<b>BBTB Date:</b>	<b>13 April 2018</b>
<b>BBTB Number:</b>	<b>BBTB-009</b>
<b>BBTB Title:</b>	<b>OmniCare Fire Telephone Build Issue</b>
<b>System Description:</b>	<b>OmniCare</b>
<b>Product(s) Affected:</b>	<b>Fire Telephones manufactured between 11/2017 - 03/2018</b>
<b>Reference:</b>	<b>PRCR 1418</b>
<b>Priority:</b>	<b>I</b>

Figure 1 — Illustration showing J2 Incorrectly Fitted.

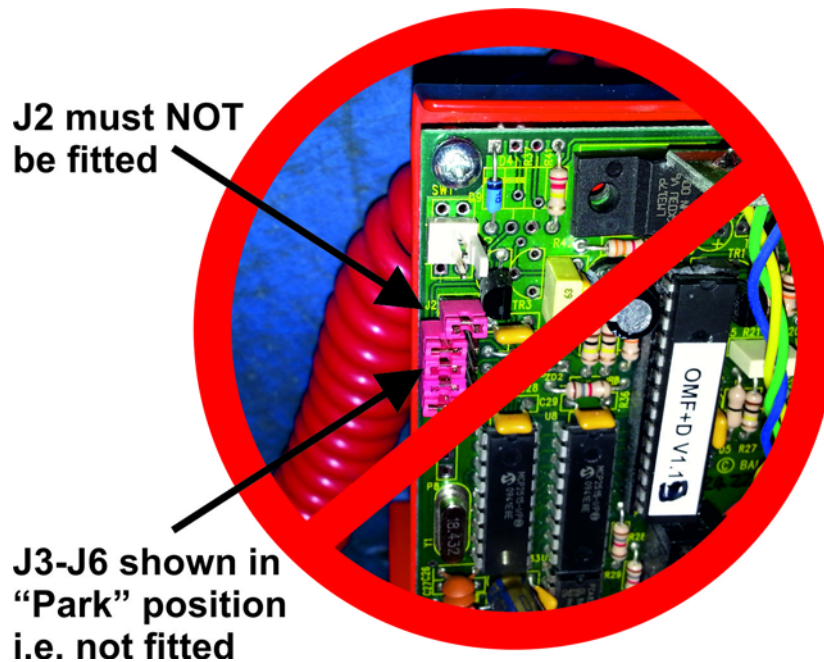
OmniCare Fire Telephone (BVOCFINT) Modules manufactured between November 2017 - March 2018 may have been supplied with J2 fitted.  
This link **should not** be fitted to the BVOCFINT module.

If link J2 is fitted the Fire Telephones will not respond correctly if a call is initiated from the Control Panel. When affected units are called and the Fire Telephone door is opened to answer the call, they will not stop ringing and a loud buzzing will be heard through the earpiece. A conversation cannot take place.

- Undo the two screws that hold the internal BVOCFINT module and carefully extract the module from the enclosure.
- Refer to Figure 1 for location of J2 and if fitted, remove it.

- Carefully refit the BVOCFINT Module into the enclosure and replace the two mounting screws.
- Perform another functional test and ensure the unit responds correctly to a call initiated at the control panel.  
Ensure a conversation can be held between the Operator and the Fire Telephone.
